BALLYMASTONE PHASE 3

RESPONSE TO LRD OPINION

Large-Scale Residential Development Stage 3
Planning Application

6884_RPBM01_Response to LRD Opinion

Figure 2-1: Proposed car parking provision for crèche and community hall facilities (extract from Traffic and Transportation Assessment prepared by DBFL)

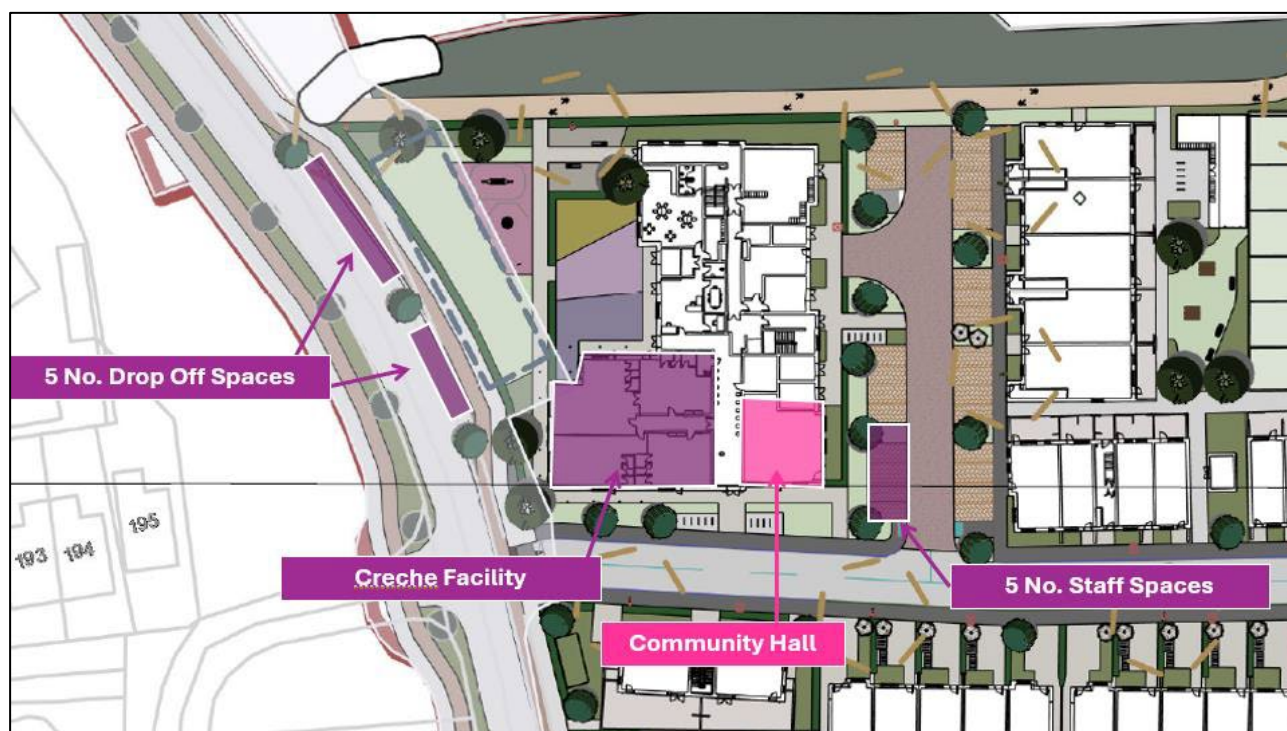
"The layout of the proposed creche appears to have 4 rooms. The applicant states in the 'architectural design statement' that car parking would be provided at a rate of 0.5 spaces per classroom with additional drop off / set down in accordance with current Development Plan standards."

- *Drop off and parking should be appropriately located and designed to ensure three-point turns are not required near the entrance to the creche, and a circuitous route could be considered if appropriate.*
- *Parallel spaces on the same side of the street as the creche are generally preferable.*
- *Appropriate size of spaces should be considered to allow for safe exit from the car and use of child seats etc.*
- *There should be control measures in place by way of signage and lining to reserve the creche set down and staff parking for the exclusive use of the creche during creche operating hours. Spaces could revert to visitor spaces outside of operational hours."*

The 5 no. drop-off spaces for the proposed creche are parallel and located on same side of the road as the creche, as shown in **Figure 2-1**, thereby enabling parents / caregivers to pull up beside the crèche, to safely access their car to get children out onto the footpath and they can then use the internal road network of the development to conveniently turn around without having to undertake three point turns on the road. These spaces will be clearly marked and signed as drop off spaces for the crèche facility.

There are also 5 no. staff spaces provided to the eastern side of the crèche facility. It is proposed that both the drop-off and staff spaces (i.e. 10 no. spaces) will be dual function and also serve the proposed Community Hall facility. Events and activities in the Community Hall are expected to generally occur outside of the opening times of the crèche. Therefore, in order to avoid an oversupply of car parking, it is proposed that these 10 no. spaces will serve both uses given they are located in close proximity to each other.
